PROJECT **123A90 - HOLLANDSE KUST NOORD WIND PARK**
BLPH Project

MECHANICAL COMPLETION DOSSIER (ONSHORE)

SYSTEM	87 Instrumentation Systems incl. general control room equipment
SUBSYSTEM	87-10-13 Junction Box 00-JE-13002 and Multi-core cable (PCS System)

PUNCH ITEM ENTRY / CLEARANCE FORM

C30002062

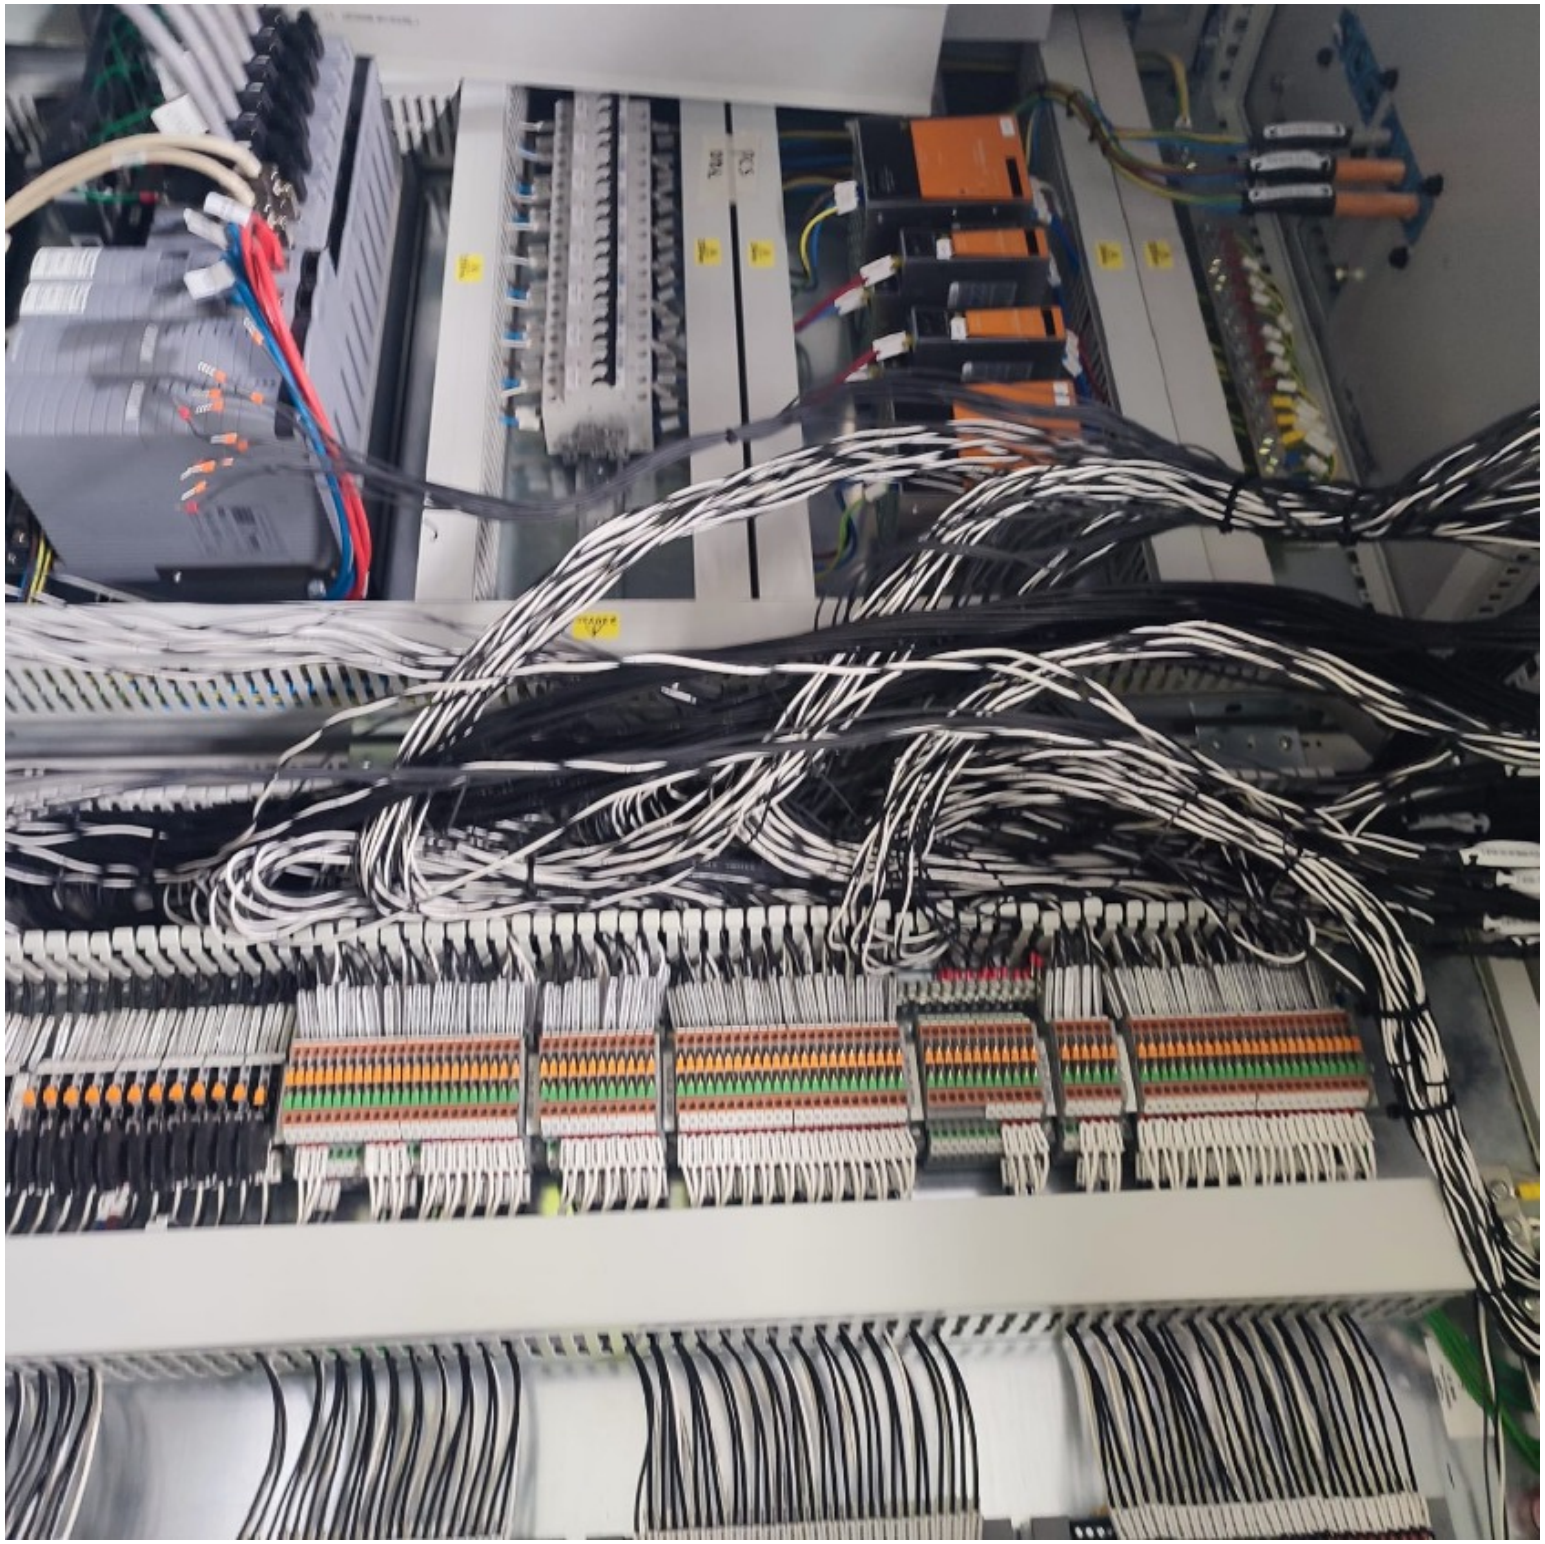
Cable must be dressed properly inside B400-PCS-002.See attached photo.

Done.

C30002047

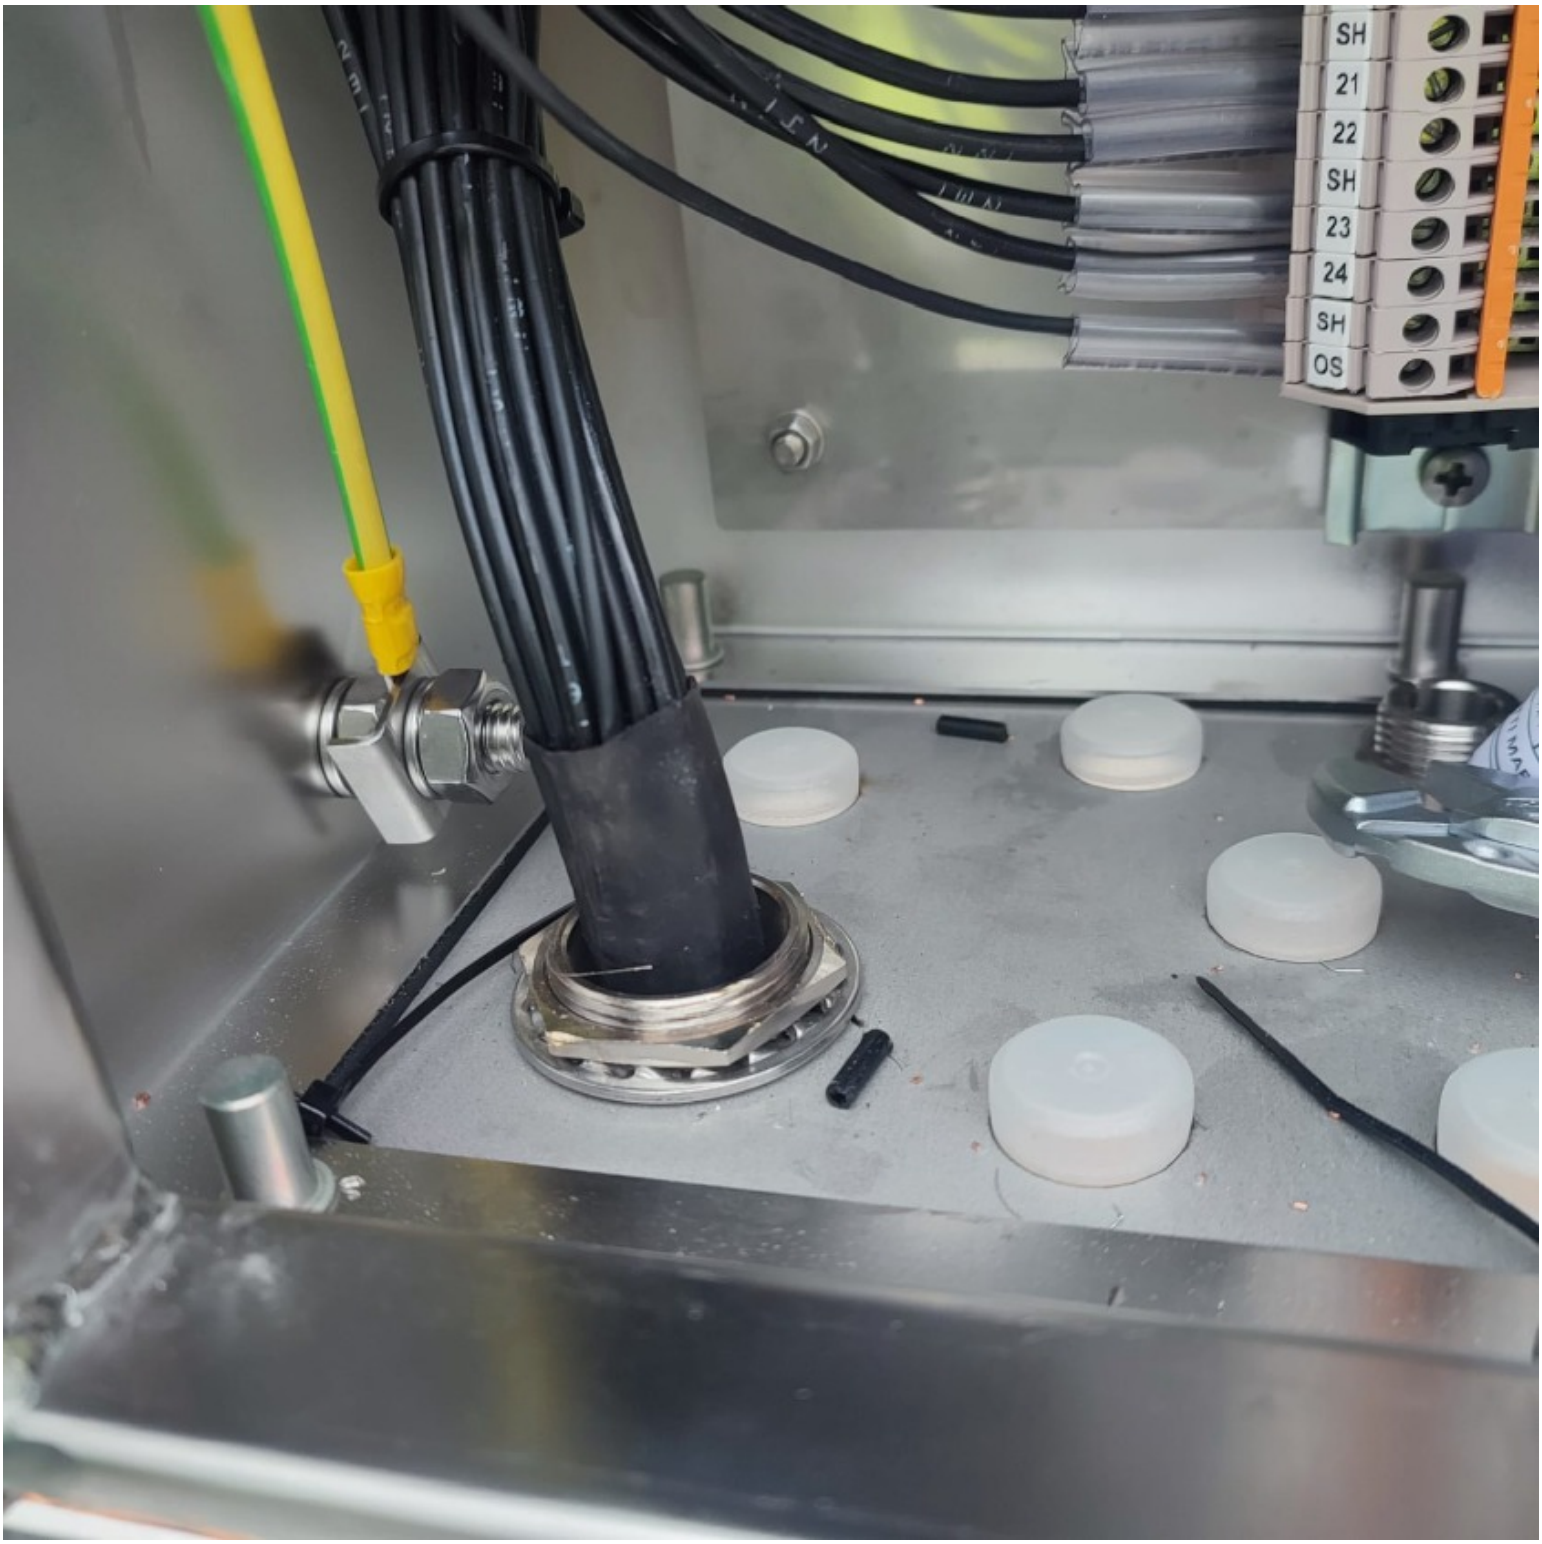
not installed certificate plug on the (00-JE-13002) .See attached photo.

DONE

C30002050

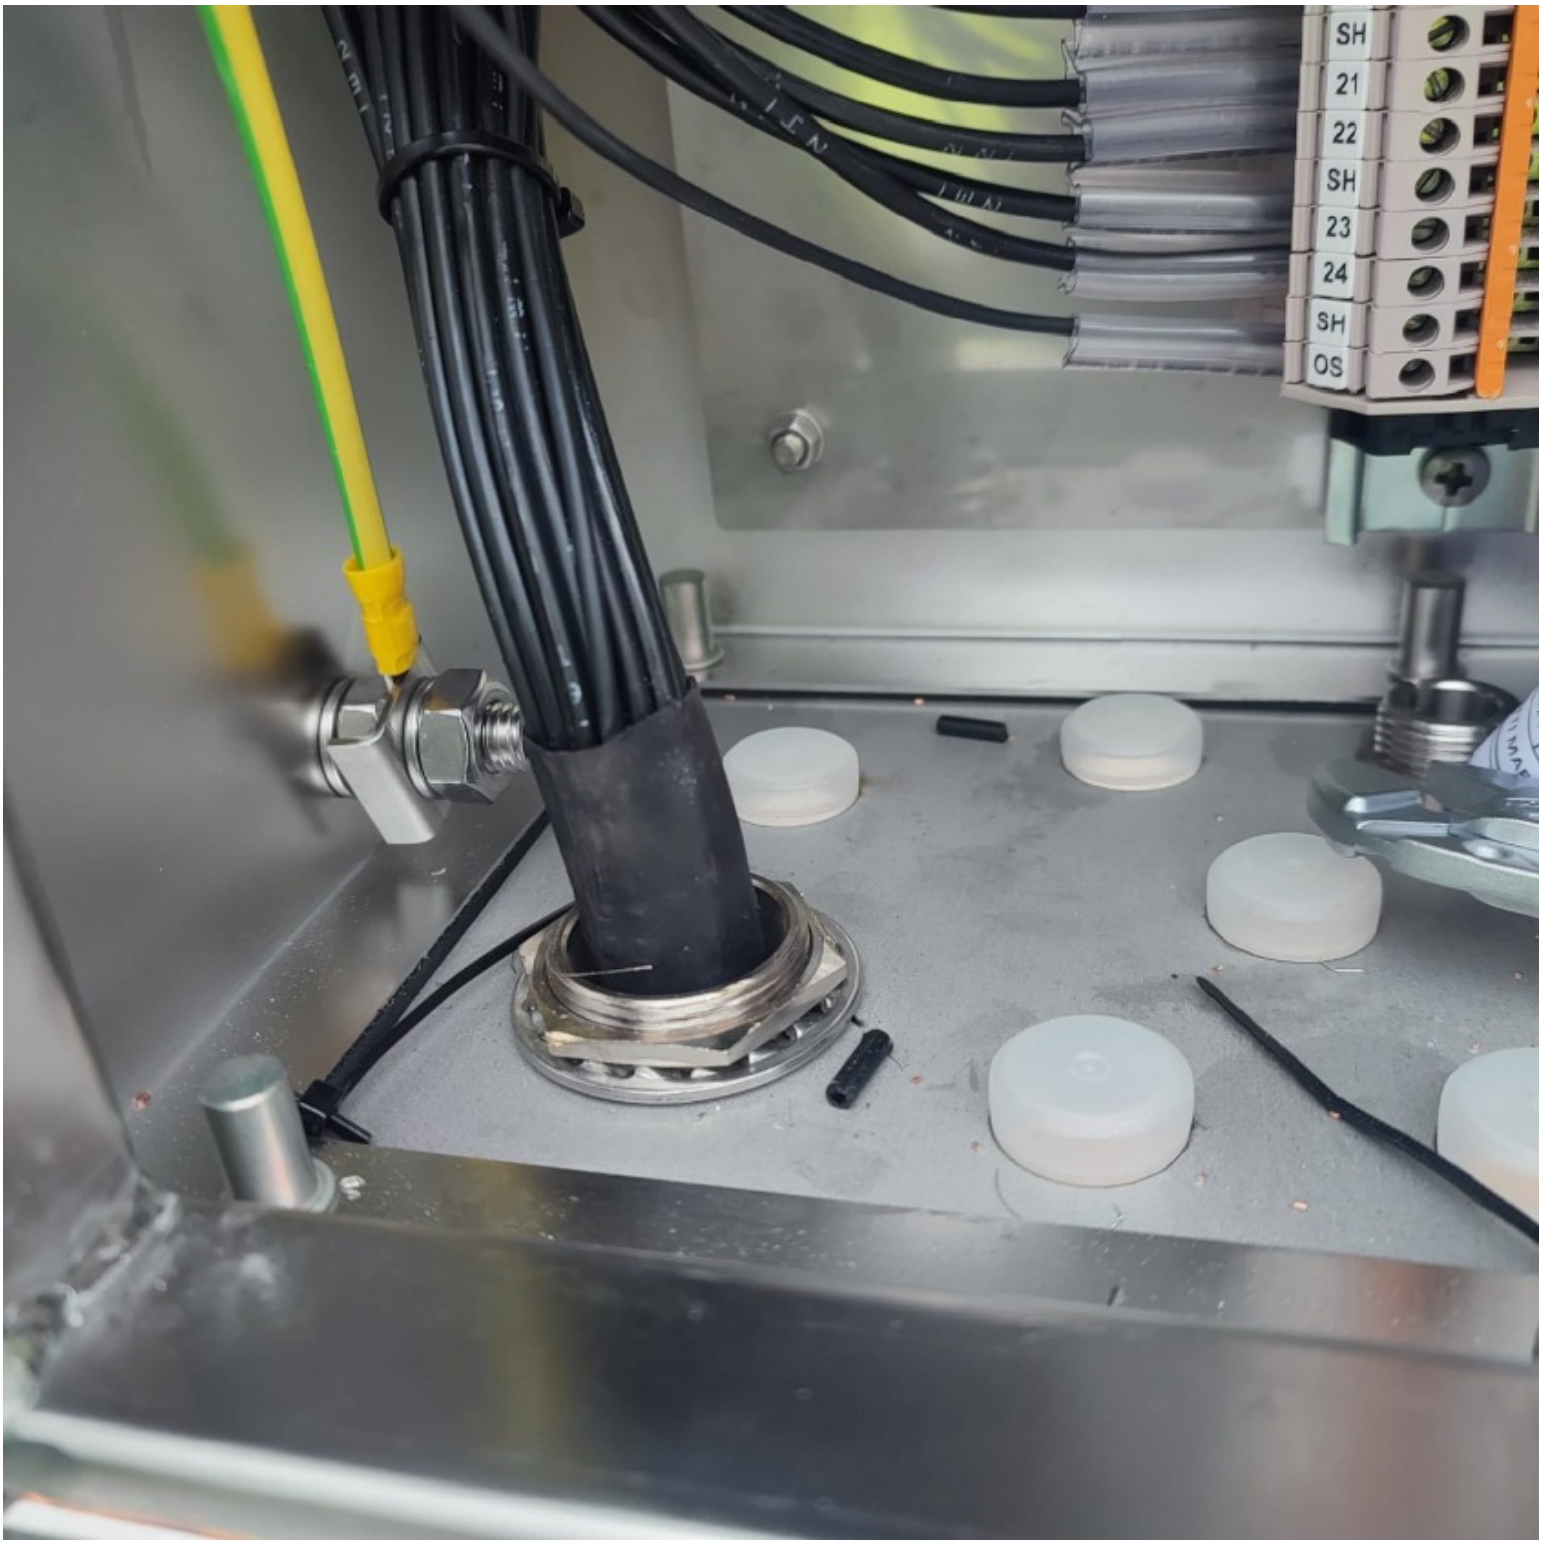
Need to be cleaned inside the 00-JE-13002.See attached photo.

DONE

C30002052

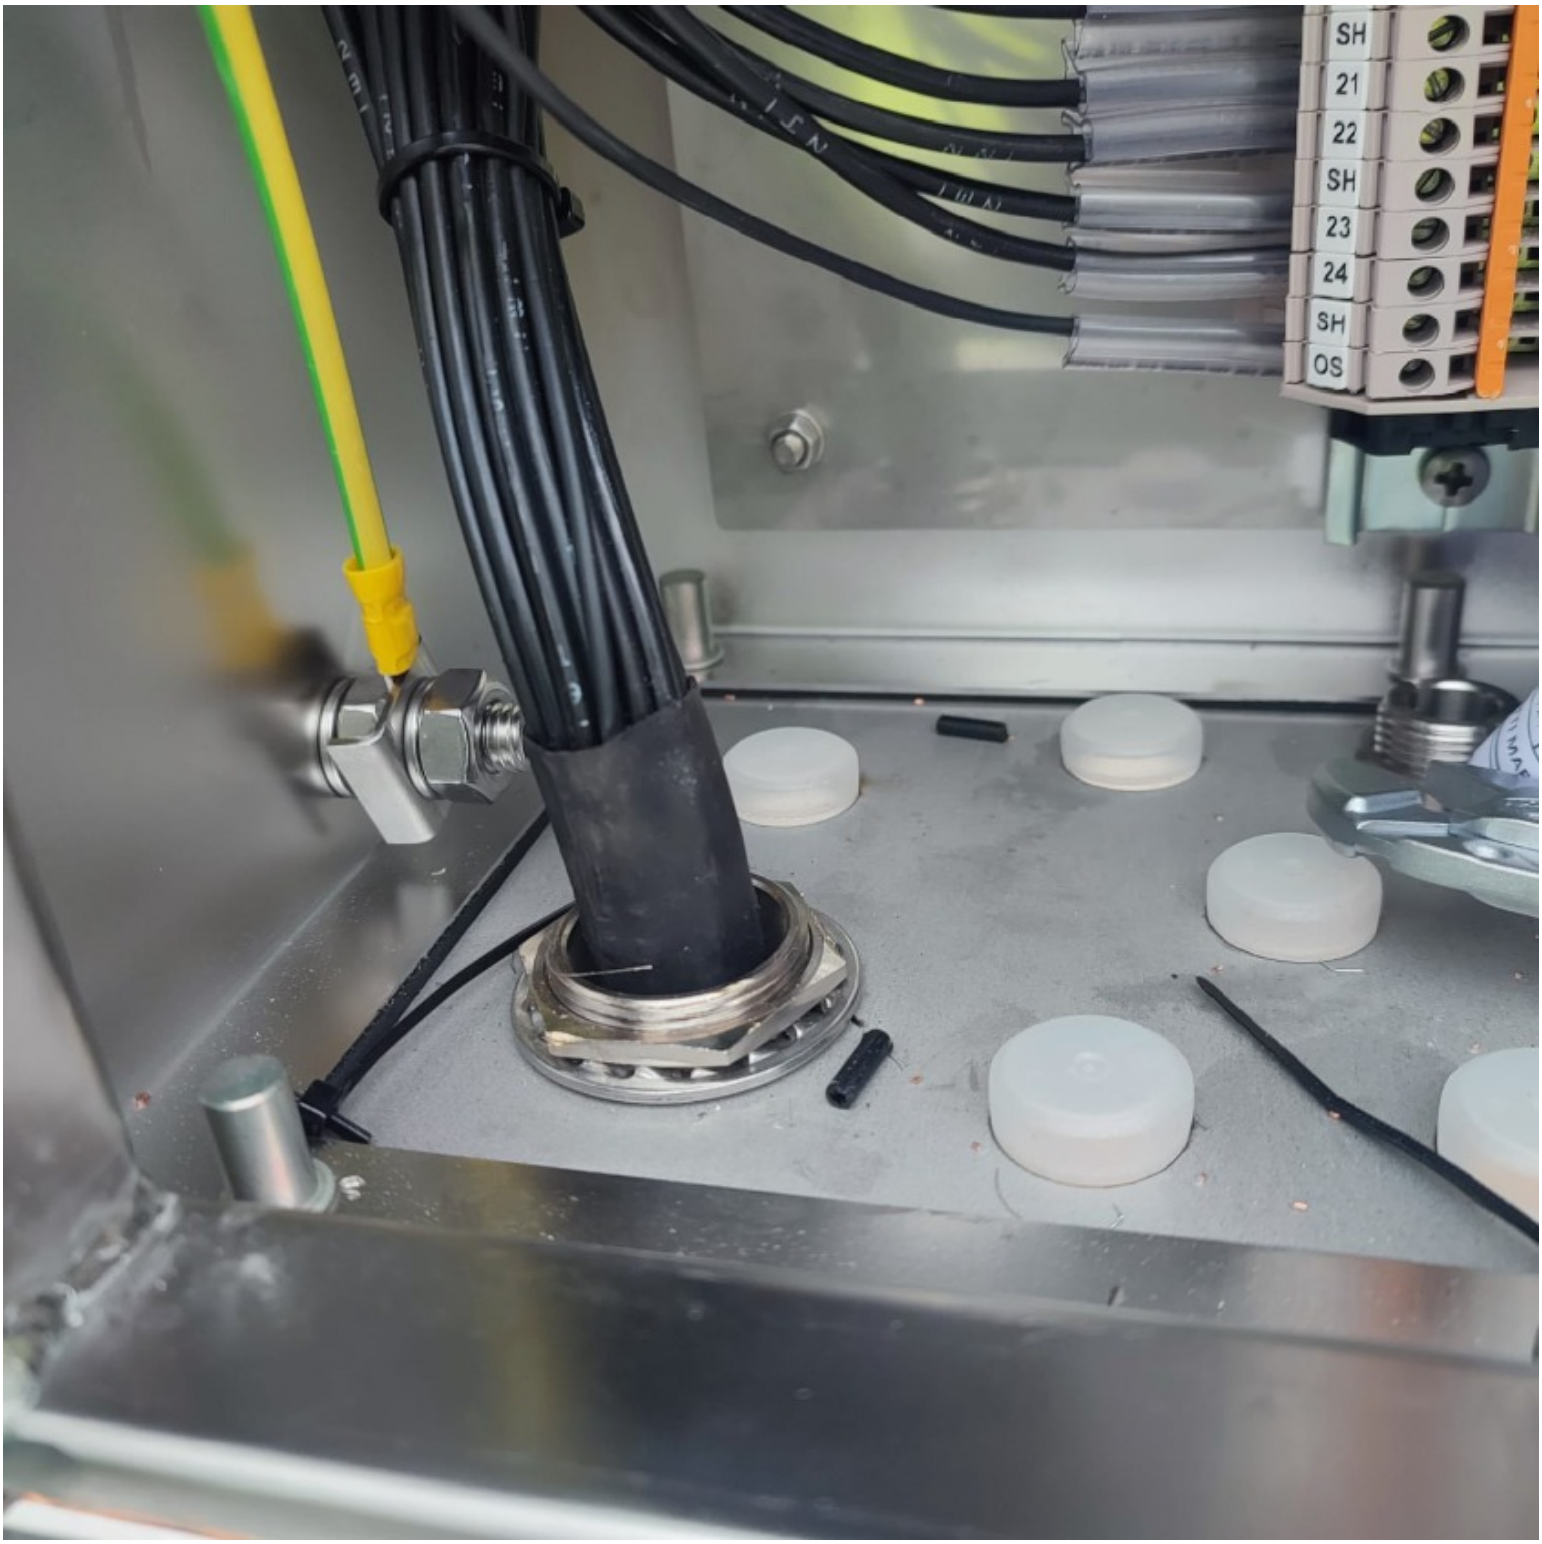
inside the jb the inner sheath of the cable does not properly exit from the cable gland.See attached photo.

DONE
